Tivoli Enterprises Ltd

SERVICE BULLETIN

RIDE: Orbiter

SUBJECT: Lap bar release handle cover

SUBJECT: CAR ATTACHMENT PINS

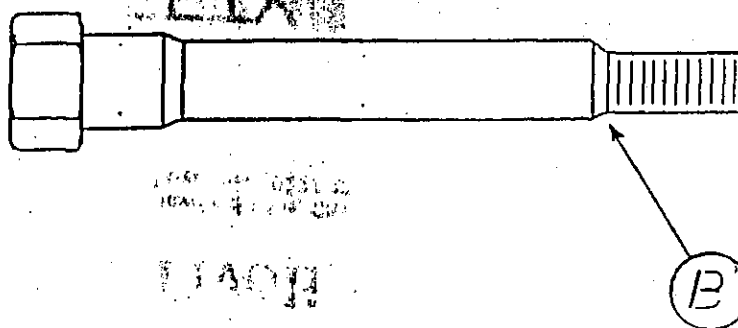
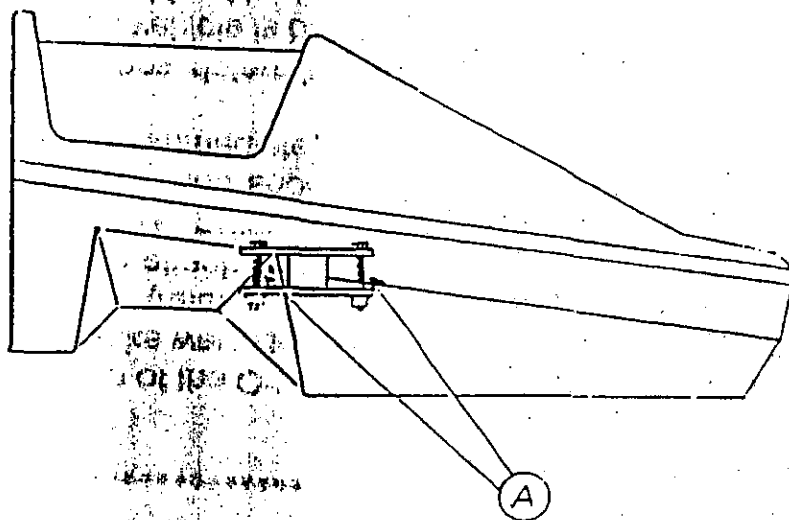
Through routine inspection of the Orbiter Amusement Ride seat attachment pins, (refer to Point A) cracks were detected in the area where the threaded portion meets the pin shaft (refer to Point B). It is recommended by Tivoli Enterprises that these seat attachment pins be inspected by an approved non-destructive testing (NDT) process to determine condition of pins. If cracks are detected, these pins should be replaced immediately. This inspection should be done immediately and then on an annual basis.

After investigation, Tivoli has determined that cracking of pins is due to excessive tightening when vehicle is being attached to sweep. As stated in the manual, these pins should not be tightened in excess of 70 foot pounds. The ride is supplied with an electrical impact wrench which is to be used only to speed the operation of installing and removing these pins. If abused, excessive tightening could damage pins. Use impact wrench to bring pins down until it meets the base metal only.

If it is in owner's or inspector's opinion that use of this impact wrench is being abused by the operator, it is recommended by Tivoli that the electric wrench be replaced with a 3/4" drive ratchet hand wrench.

Drawing: ORSA002A

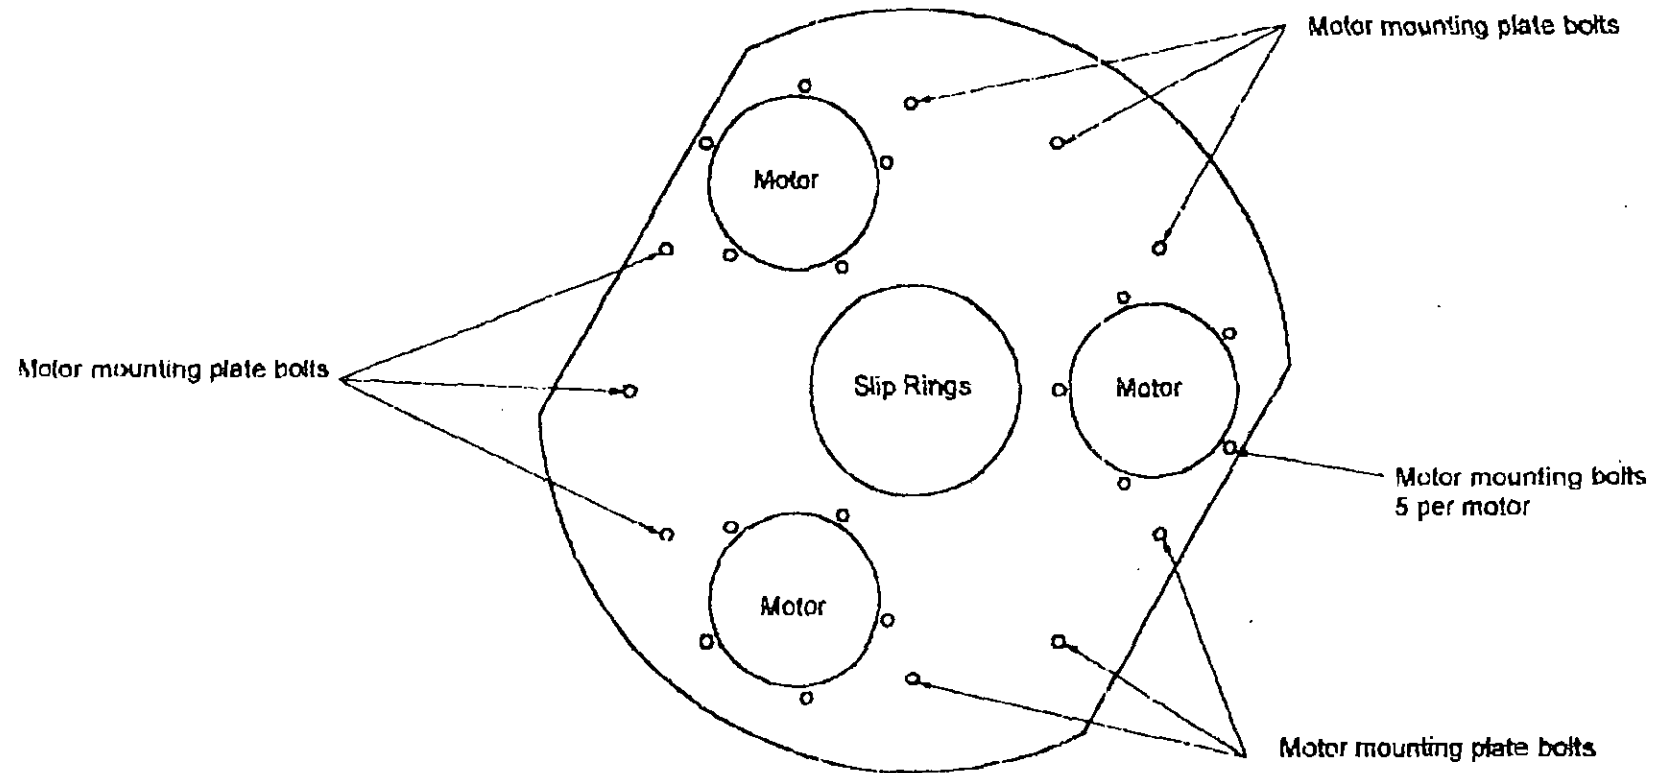
- 9 – 12mm x 45mm bolts spread equal distance around outside parameter of plate. See Attached drawing ORSA002A.

Bolt Specification, three motors and motor mounting plate.

Bolt: Hex head, 12 mm x 45 mm x 1.75, grade 8.8, partial thread, black finish. Ref: DIN 931 / ISO4014

Washers: 12 mm, flat hardened washers, 13 mm ID, 24 mm OD, 3 mm thick. C45. Ref: DIN 6916

Tightening Torque Requirements: Tighten bolts to 85 ft / lbs.

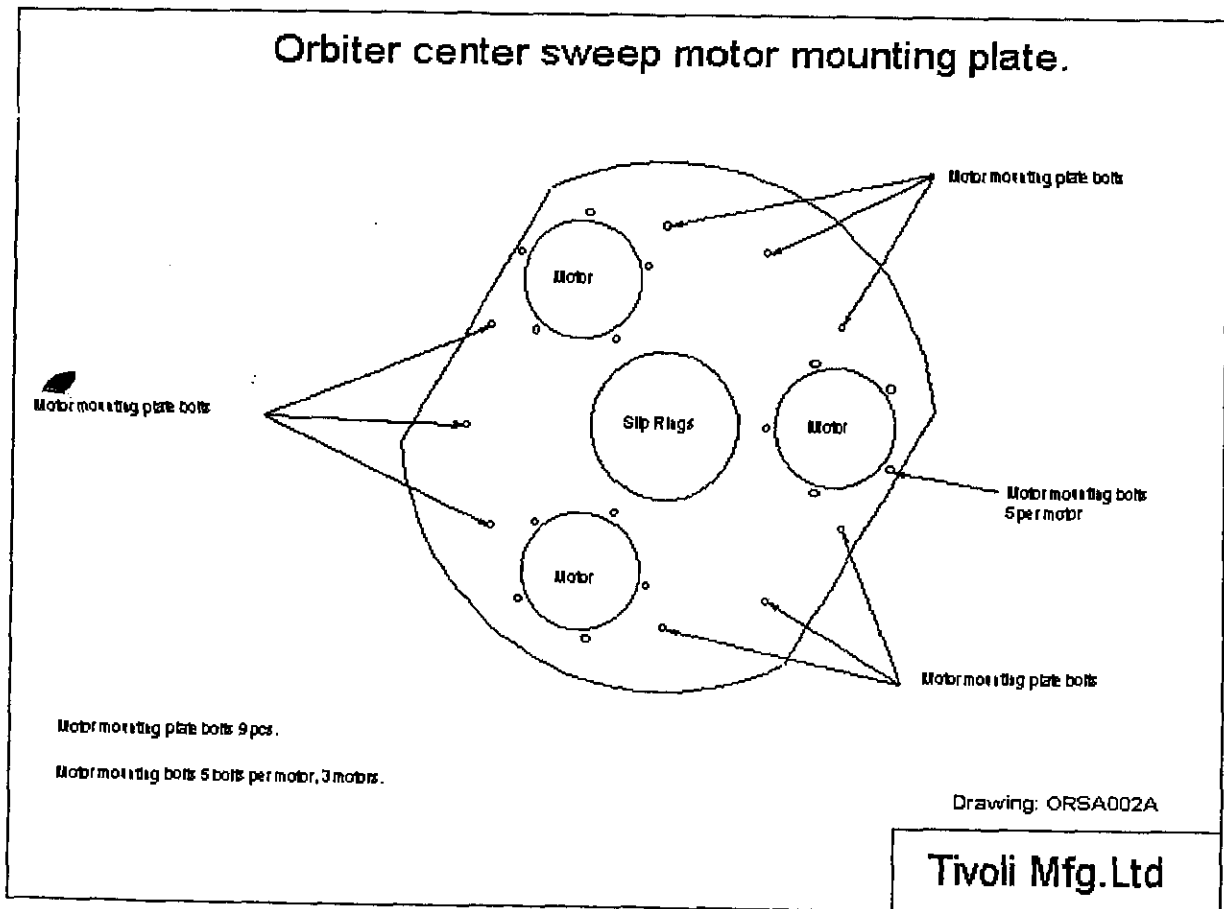
Bolt Testing procedure:

In order to test and assure motor mounting bolts have remained tight to their recommended torque value the following procedure must be followed;

- Obtain a torque wrench (or equivalent) capable of attaining a tightening torque between 0 and 100 ft-lbs. **Important:** Assure the torque wrench is in good working order and is properly calibrated.

- Use a 19mm socket with wrench.
- Set torque for 60 ft-lbs. **Do not set over this value.**
- Using torque wrench attempt to tighten each bolt until the torque wrench indicates (clicks) 60 ft-lbs.

- As the bolt is tightened visually check socket for rotation.
 - The socket should not turn before the indication (click) is reached. This will indicate that the bolt is remaining at its correct torque. **If each bolt passes this test there is no further testing required**

- If the socket turns before the indication (click) is reached, the bolt has loosened and both bolt and washer must be replaced.
 - If loose bolts are detected notify Tivoli Mfg. Ltd. or AmTech in order to determine if further testing or investigation is necessary.

Vehicle Connection Frame

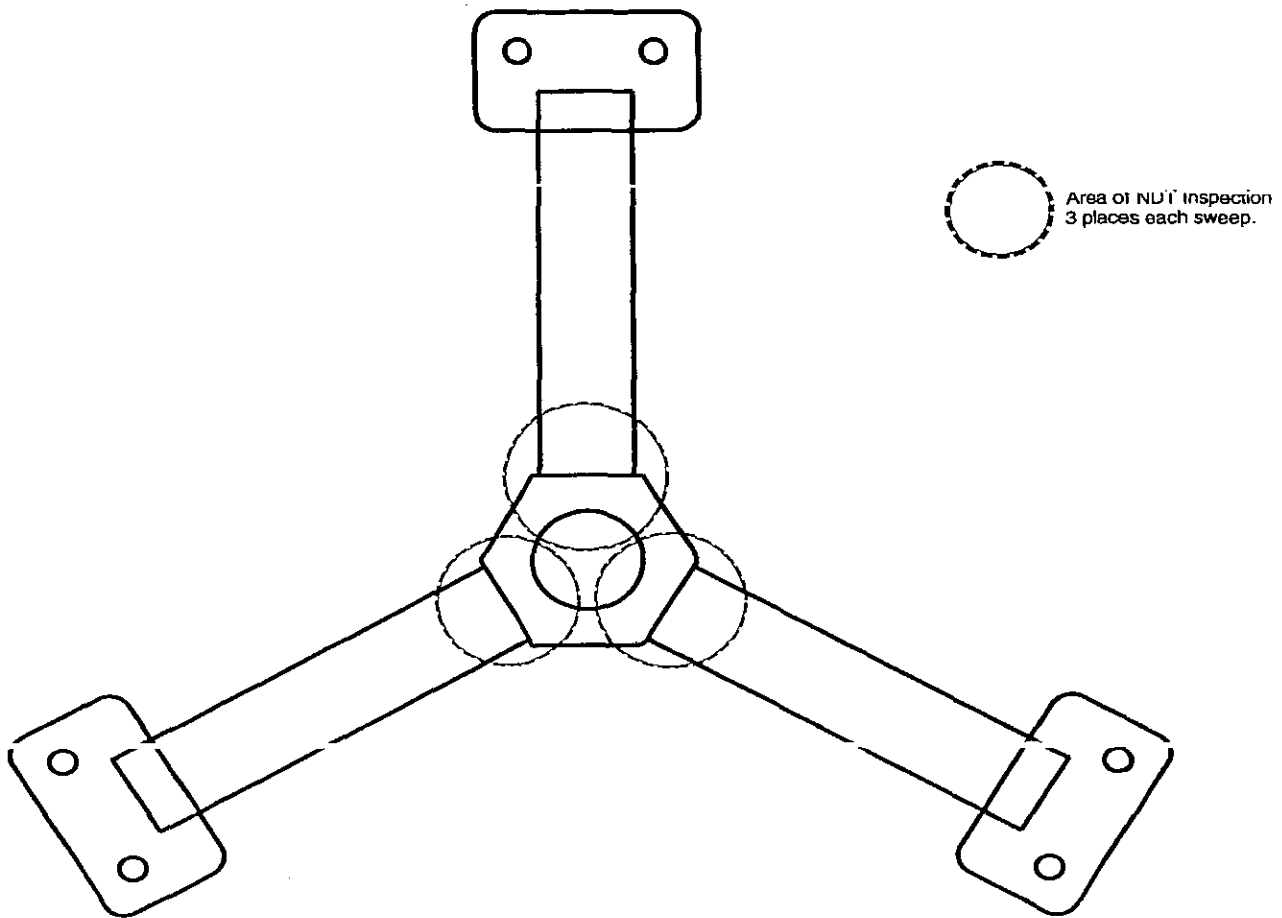
The cause of the separation of the vehicle was caused by a combination of corrosion and cracking of the welded tubing at the weld joint of the attachment frame as indicated in the accompanying drawing.

Tivoli requires that the welded connection and tubing in the area noted in the drawing be tested by magnetic particle NDT testing and visually checked for corrosion. Any additional testing or change in procedure will be at the discretion of the testing technician.

Report and irregularities to Tivoli Mfg. Ltd or its Representative for proper repair procedures.
